OPTIONAL SERVICE BULLETIN

NO. OSB40-031/1
NO. OSBD4-034/1
NO. OSBF4-006

Installation of Winter Baffle in Wing Fresh Air Inlet.

„WINTER BAFFLE FRESH AIR INLET“

| Datum: 04.11.84 Gepr. von: GFK | | Nächster Zusammenbau: D41-5300-00-00 | | Zeichnung Nr.: D41 D41-5310-00-00-01 | |

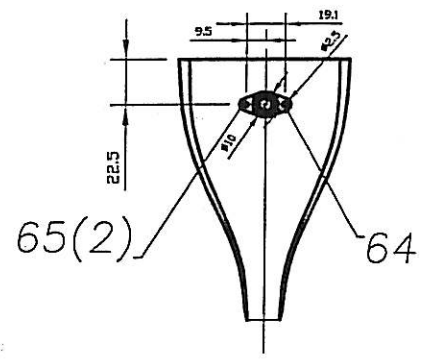
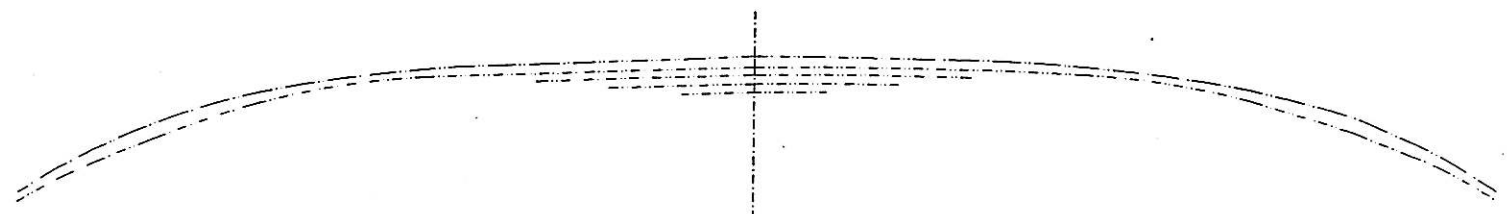
| 1 | Mark Positions for holes according to Dwg.No. D41-5310-00-00x01 |
| 2 | Drill 2 • 2.4mm holes and 1 • 10mm hole on marked positions. |
| 3 | Install Camloc receptacle, part number 212-12N, with rivets, part number CCR244SS-3-04 (or DIN 7337-B 2,4 x 8,5). |
